## 1 Proposed baseline for D3.1:

This is an overhaul for the LLDP specification in Clause 79, specifically addressing dual-signature operation. It aims to address the issues raised in comments [D2.4](#) #130, #293, #294, #296, and #297.

The general state change procedure for PSEs is shown in Figure 145–43.

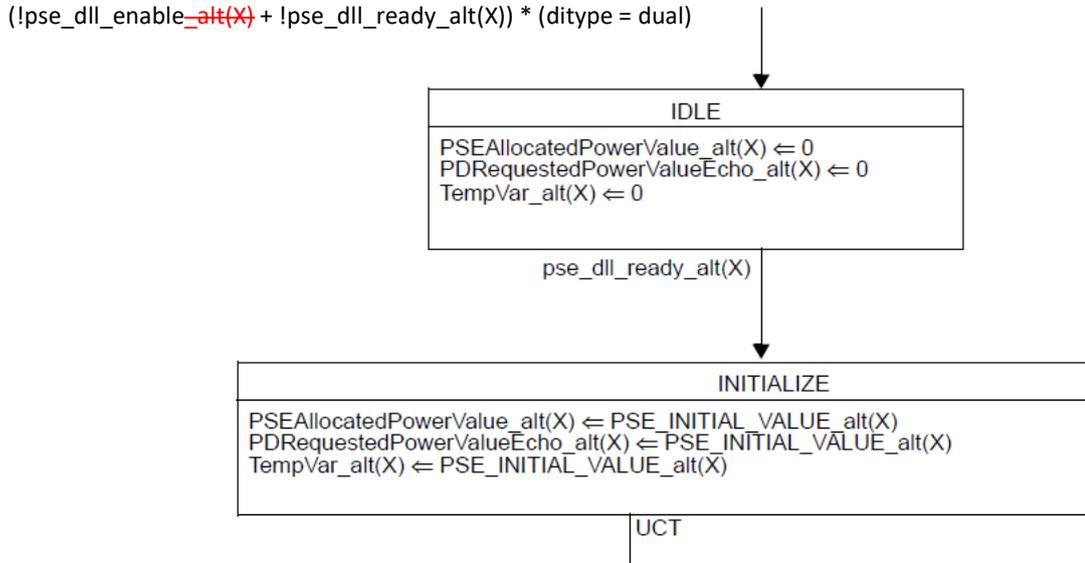
**Info (not part of baseline)**  
 pse\_dll\_enable\_alt(X) is unified to pse\_dll\_enable.

7 The general state change procedure for PDs is shown in Figure 145–44.

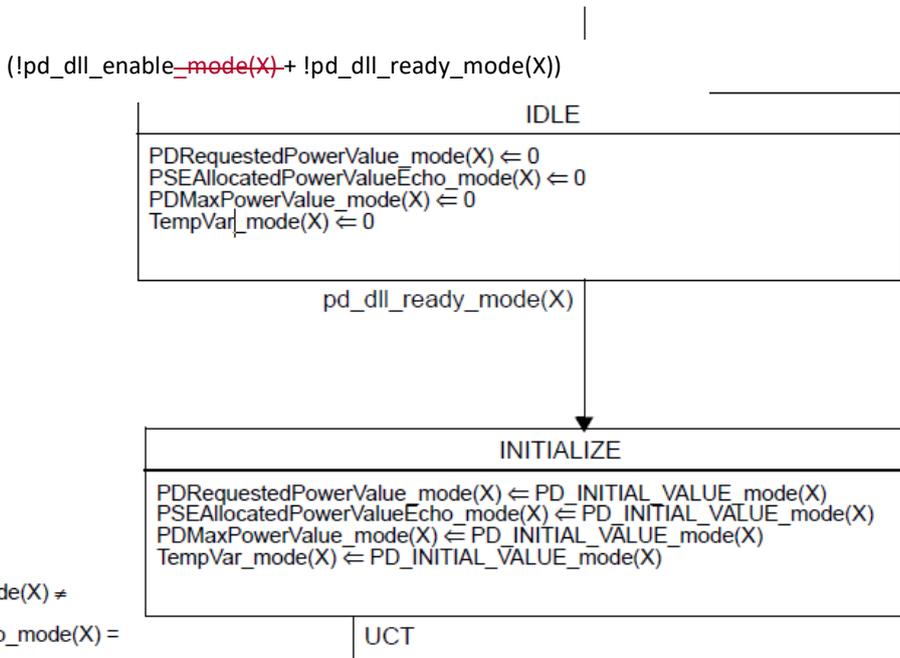
**Info (not part of baseline)**  
 The same applies to PDs, they need to follow the relevant state machine pending the result of the connection check and not flip between state machines even if dual-signature transitions from 4 pair to 2-pair and vice versa.  
 The same applies to PDs, they need to follow all of the state diagrams. For a single signature, this means that the state diagrams for dual signature will stay in the IDLE state, thereby setting the A and B fields to zero.

10  
 11 Single-signature PD Data Link Layer classification shall provide the behavior of the state diagram defined in Figure 145–41  
 12 ~~and~~ Figure 145–42, ~~and~~ Figure 145–44. Dual-signature PD Data Link Layer classification shall provide the behavior of the  
 13 state diagram defined in Figure 145–44.
